TITLE:-4LEAF BOTH SIDE SLIDING
CRM DOOR-10

CLIENT - LESTECH
LOCATION - POSCO MANGAON
PRODUCT - SLIDING DOOR
If any queries contact : design@nihva.com
DWG NO:-NIHVA/22-23/CLT/0017 REV- 0
ALL DIMENSION ARE IN mm
SCALE: NTS SCALE:-- 1:1 SHEET: 01 OF 01

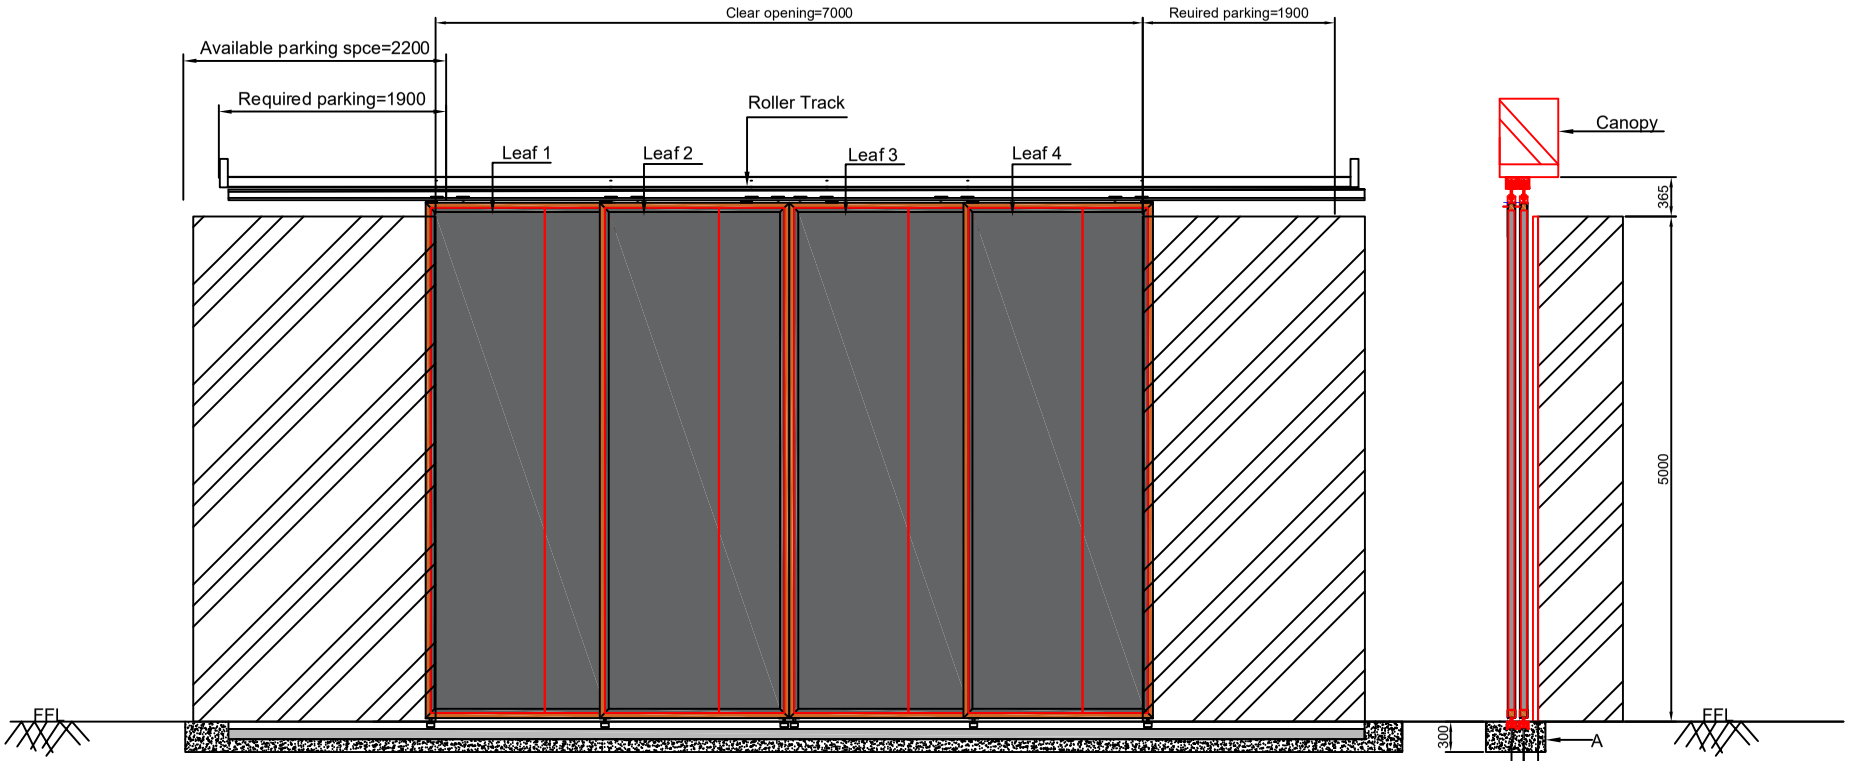
Client scope
*Roof need to be shift at top Approx 300mm *Drainage area need to be remove frome left side appox.200mm *Gutter area need to be remove *Civil foundation need to be done for tracks
